Technical change to RSMS relay interfaces

PCN-number: 20210818

Representative RSMS 8 relay interface

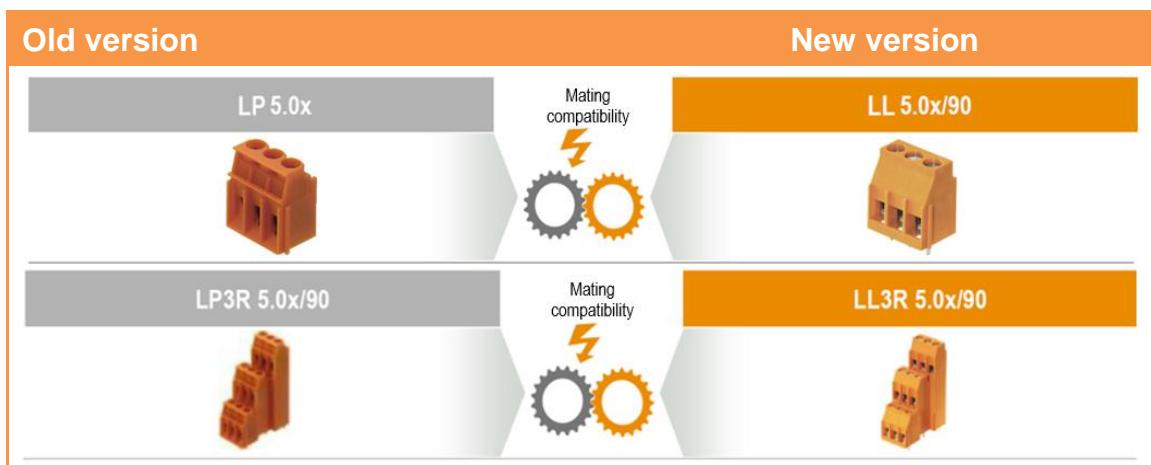
Based on continuous improvement the LP and LP3R connectors will be replaced by LL and LL3R connectors with Tampoprint.

Obsolescence of LP and LP3R connector range and addition of **UL-recognized** approvals (UL) on the label for these products, making each interface UL recognized.
